DESIGN AND ACCESS STATEMENT
23 ROCHESTER ROAD
CAMDEN

Date	Rev	Notes
14.07.2014	P1	Planning Submission

Site address: Ground Floor Flat
23 Rochester Road
Camden
London
NW1 9JJ

Ref: 2014/2541/PRE

Proposed Basement and Lower Ground Floor plans, as proposed under this application

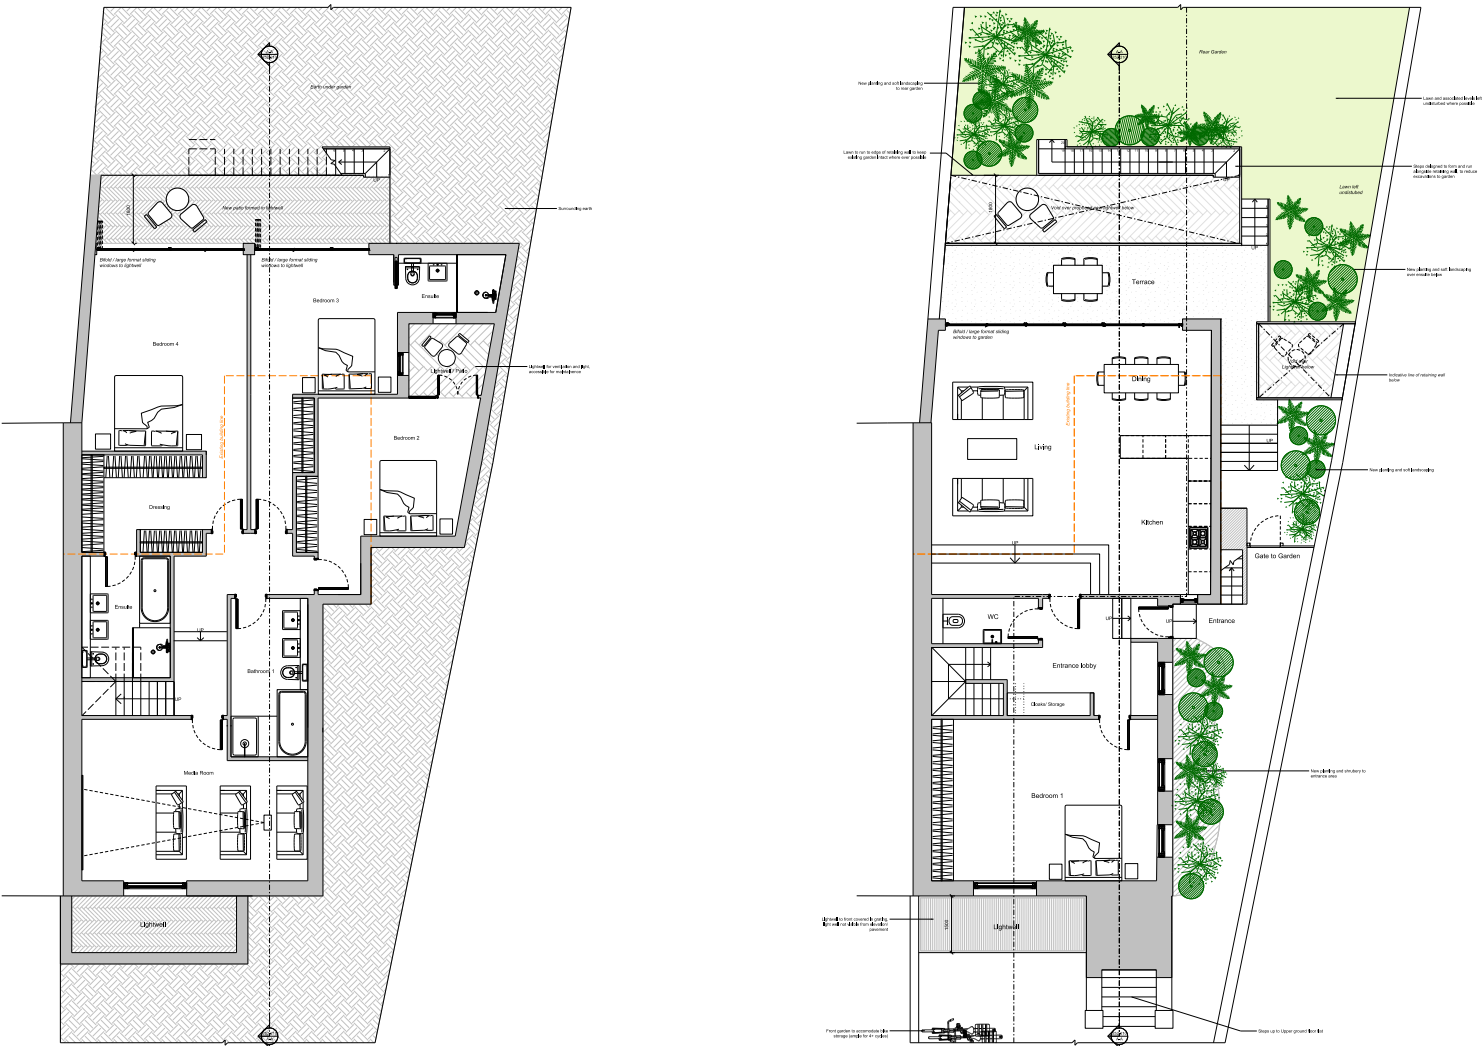
However this proposal also includes the installation of a rear lightwell, which would extend approximately 2.7m further into the rear garden, with further steps leading up to it from basement level. As discussed on site, a more preferable approach would be to reduce the depth of the staircase and lightwell so that the extent of rear garden which is lost by the proposal is kept to a minimum.

However some concern is raised about locating all three bedrooms at basement level, which would limit the levels of natural daylight and outlook reaching these principal rooms. Any application would need to demonstrate that satisfactory levels of natural light and outlook are achieved to at least the two main bedrooms – this may be possible due to the relatively deep rear lightwell, but re-locating one of the bedrooms to ground floor level is considered the preferred option.

This has been reduced from 2.7m to 1.8m. The stairs line the perimeter edge of the lightwell so as not to 'eat into' the garden in a more invasive way

As such we have relocated a bedroom to the ground floor level at the front as suggested.
